**SAN ANTONIO WATER SYSTEM
RECYCLED WATER INTERCONNECT
FLOW CONTROL VALVE
SAWS Job No. 09-8605
Solicitation No. B-10-036-DD**

**ADDENDUM NO. 2
July 13, 2010**

RECYCLED WATER INTERCONNECT FLOW CONTROL VALVE PROPOSED PLAN & PROFILE			
DEVELOPER: SAN ANTONIO WATER SYSTEM CONT. BUDGET PROJ.			
SUBMITTED _____ APPROVED _____			
MAP NO.	NO.	SHEET C-02	
DRAWN BY: WOG CK.		JOB NO. 09-8605 OF 27

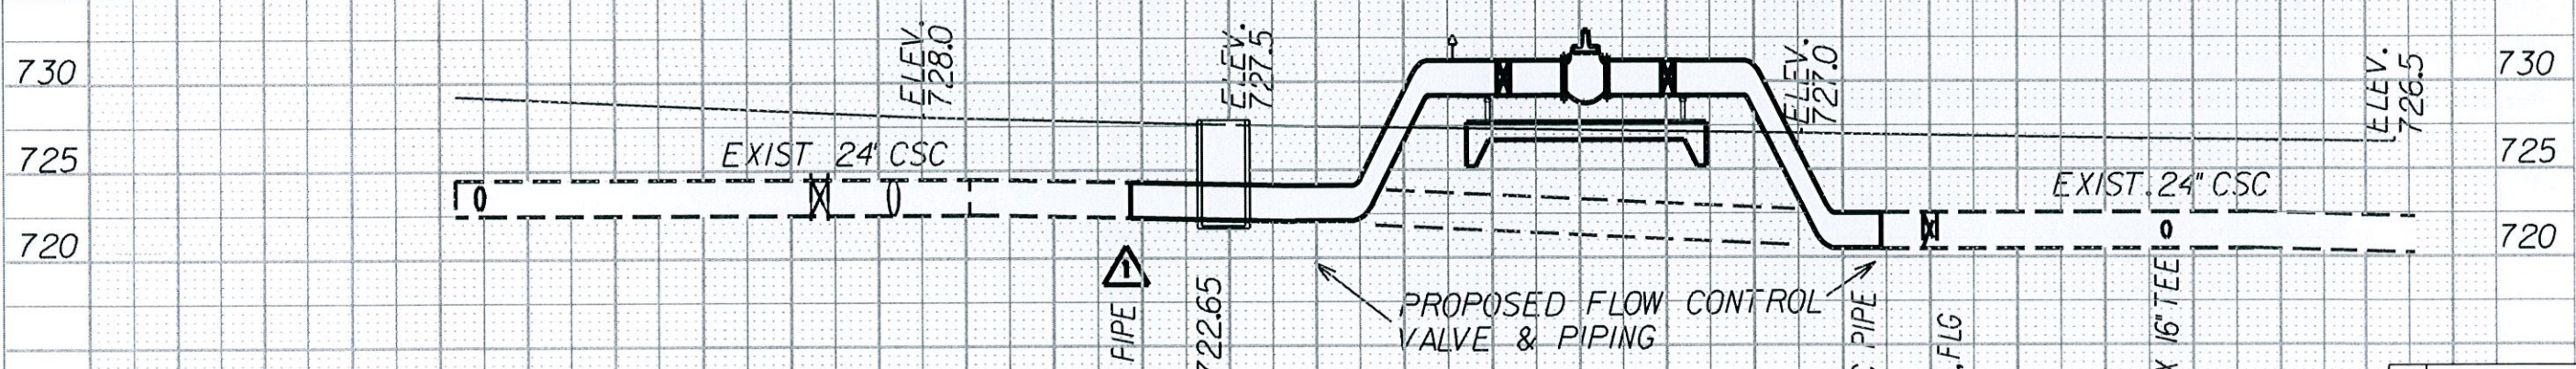
- Q2. Concern was expressed regarding the ability of the flow meter to work on CSC pipe.
A2. Please see Addendum No. 2, Items 15 through 18.
- Q3. The Separate Documents specified at the bottom of page two (2) of the Table of Contents are missing from the Specifications. Will these be issued by addendum?
A3. It is standard practice to reference these separate documents in the specifications. These documents can be accessed via the Internet as follows:
COSA Standard Conditions for Public Works Construction (latest edition)
<http://www.sanantonio.gov/cims/StandardSpecificationsV2.asp>
SAWS Specifications for Water & Sanitary Sewer Construction (latest edition)
http://www.saws.org/business_center/specs/constspecs/

15. Sheet C-02, PROPOSED PLAN & PROFILE, REPLACE this drawing in its entirety with the attached sheet.

EXTEND PROPOSED STEEL PIPE			
NO.	REVISIONS	APPROVED	DATE

EXTEND PROPOSED STEEL PIPE		APPROVED	DATE
NO.	REVISIONS		
		RECYCLED WATER INTERCONNECT FLOW CONTROL VALVE FLOW CONTROL VALVE PROFILE VIEW	
DEVELOPER: SAN ANTONIO WATER SYSTEM		CONT. BUDGET PROJ.	
SUBMITTED		APPROVED	
MAP NO.	NO.	SHEET C-04 OF 27	
DRAWN BY: WOG CK.		JOB NO. 09-8605

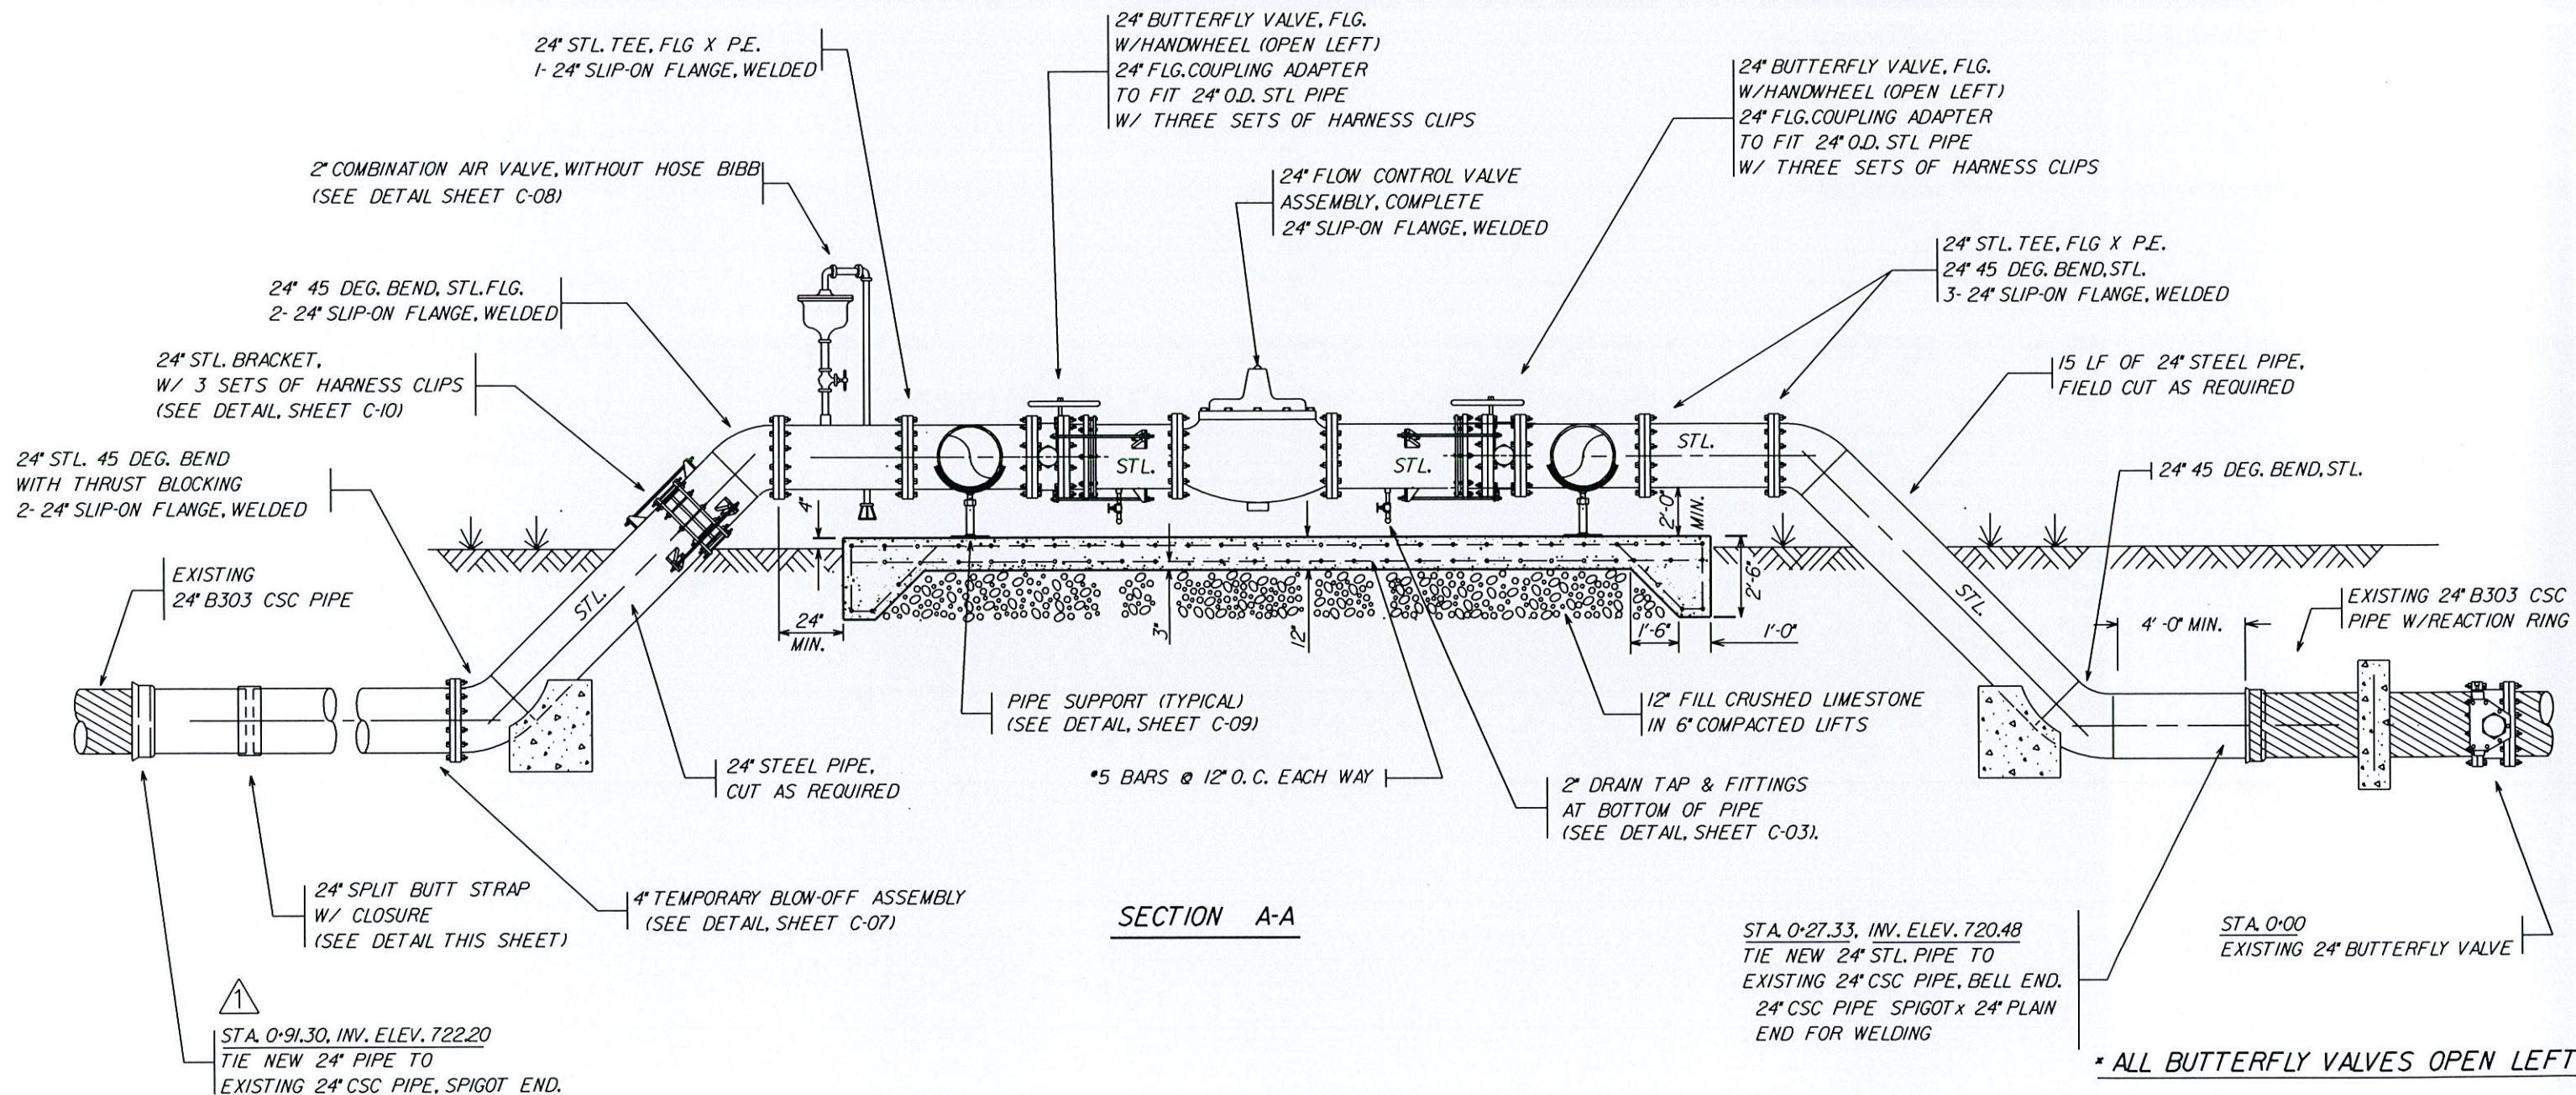
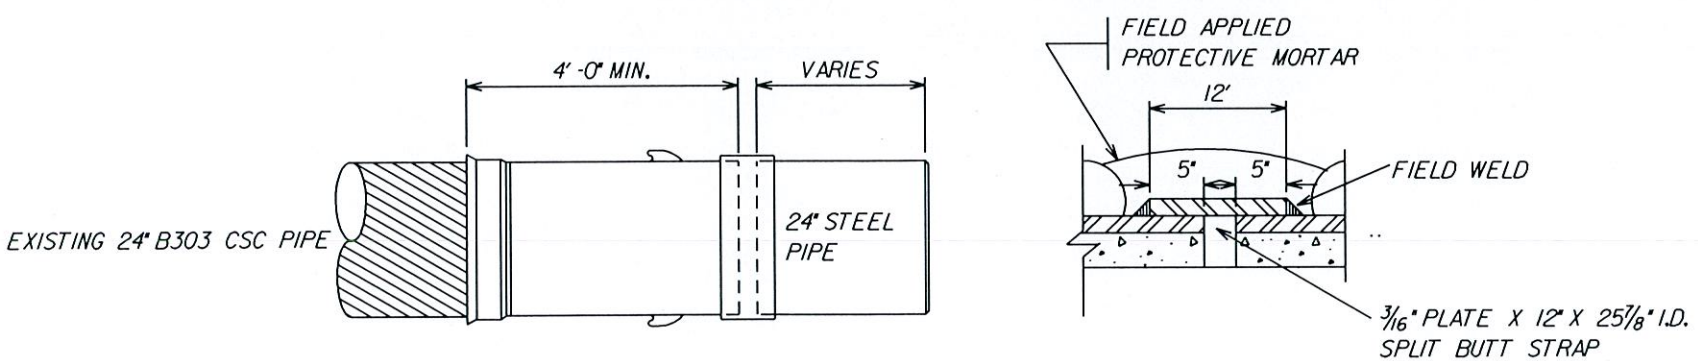
17. Sheet C-04, FLOW CONTROL VALVE PROFILE VIEW, REPLACE this drawing in its entirety with the attached sheet.

24" SPLIT BUTT STRAP W/ CLOSURE DETAIL
